## 2015 Michigan Residential Code Errors and Conflicts

The following are errors and conflicts that have been identified at this point. The Bureau of Construction Codes has reviewed these issues. The Director of Department of Licensing and Regulatory Affairs has delegated the authority to make, and has approved, the following determinations which are binding on all enforcing agencies.

FIGURE R507.2.1(2)  
PLACEMENT OF LAG SCREWS AND BOLTS IN BAND JOISTS

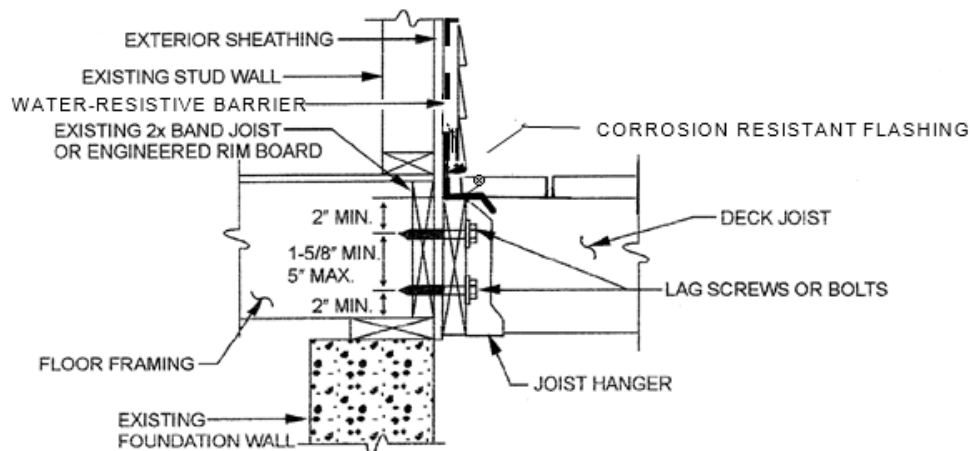
Figure R507.2.1(2) was obviously corrupted during the publication of the rules and was not noticed until it was published by the International Code Council. The figure that must be used by all enforcing agencies is now provided.
